Professional Snagging Inspection Report

Pre-completion inspection

Sample Development - Plot XX

Inspector: South Wales Snagging Co

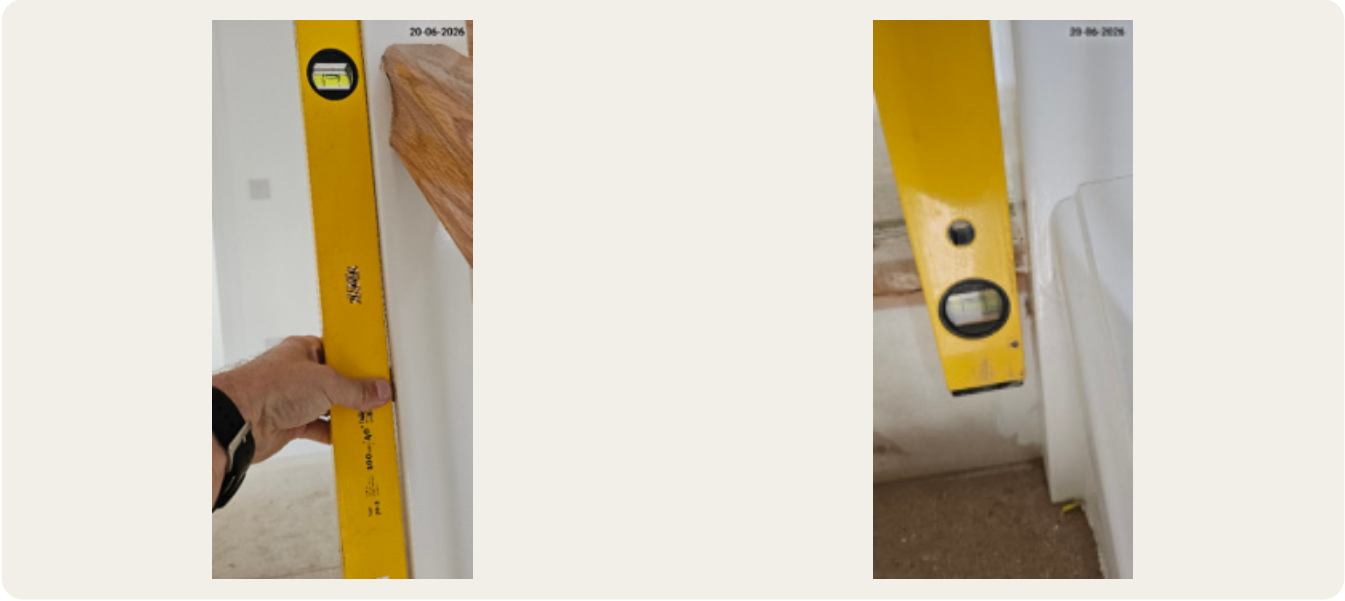
OBSERVATION
The newel post at the top of the stairs is out of plumb.
